Technical Service Information

THM 4L60-E SOFT 1-2 UPSHIFT

96-16
Page 1 of 1

Figure 1

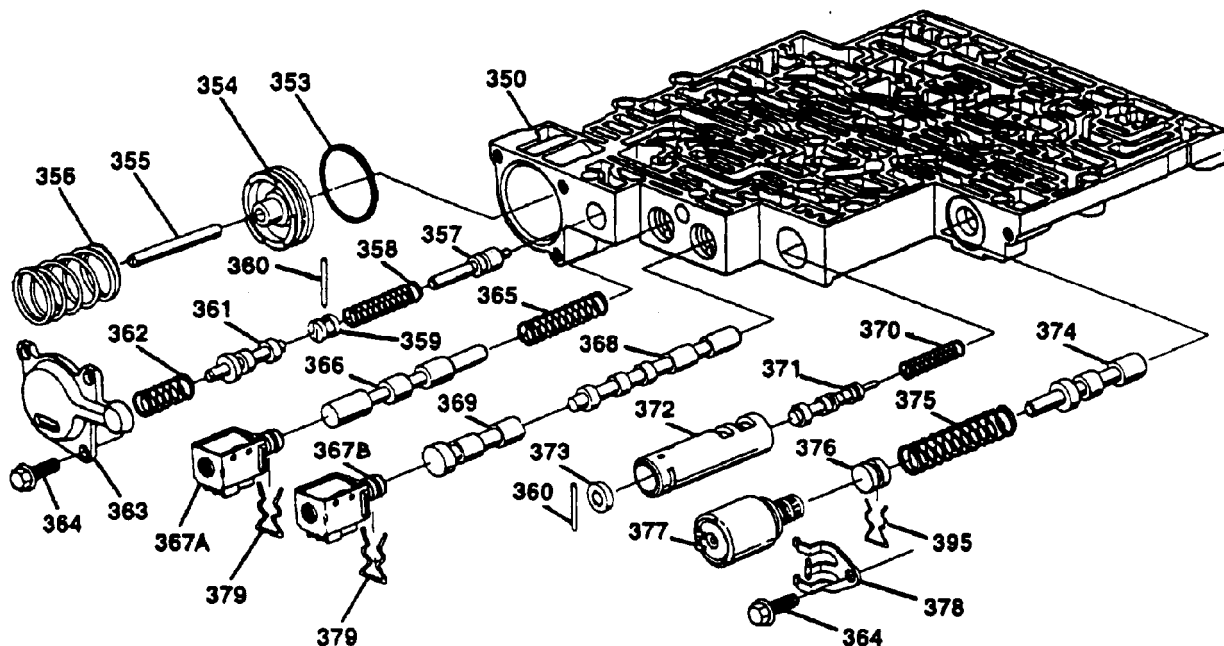
COMPLAINT: Some 1994 model vehicles, equipped with the THM 4L60-E transmission may exhibit a soft 1-2 upshift condition.

CAUSE: The cause may be, calibration of the 1-2 accumulator valve in the valve body.

CORRECTION: There is now available a new calibration service package consisting of a 1-2 accumulator valve, valve spring, and 1-2 accumulator valve bushing for the valve body. These are items 370, 371, and 372, as shown in Figure 1 below. This new service package is available under OEM part number 24202698.

1-2 Accumulator Valve Service Package 24202698
